NUMBER: 23-027-15

Rear Door Rattle Noise

This bulletin involves testing left rear door lower latch operation and if necessary, replacing the rear door center striker in addition to the upper and lower rear door latches.

2014	(VF)	Ram Pro Master (NAFTA)
------	------	---------------------------

Fig. 1 Left Rear Door Lower Latch

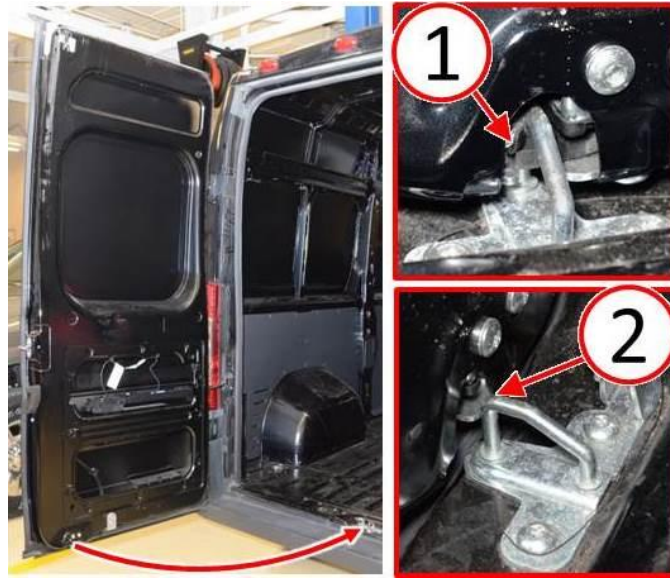
The customer may describe a rear door rattle noise and/or a rear door lower latch not working properly. An example of a properly functioning latch (1) and malfunctioning latch (2) are shown in ([Fig. 1](#)).

1 - Proper Latch Operation - Latch Fully Engaged With Door Closed

2 - Latch Malfunction - Latch Not Engaged With Door Closed

1. Replace both right and left rear door upper latches. Refer to the detailed service procedures available in DealerCONNECT> TechCONNECT under: Service Info> 23 - Body> Doors - Rear> LATCH, Door, Rear Upper> Removal/Installation.
2. Replace the rear door lower latch. Refer to the detailed service procedures available in DealerCONNECT> TechCONNECT under: Service Info> 23 - Body> Doors - Rear> LATCH, Door, Rear Lower> Removal/Installation.
3. Replace the rear door center latch striker and fasteners. Refer to the detailed service procedures available in DealerCONNECT> TechCONNECT under: Service Info> 23 - Body> Doors - Rear> STRIKER, Door Latch> CENTER> Removal/Installation.
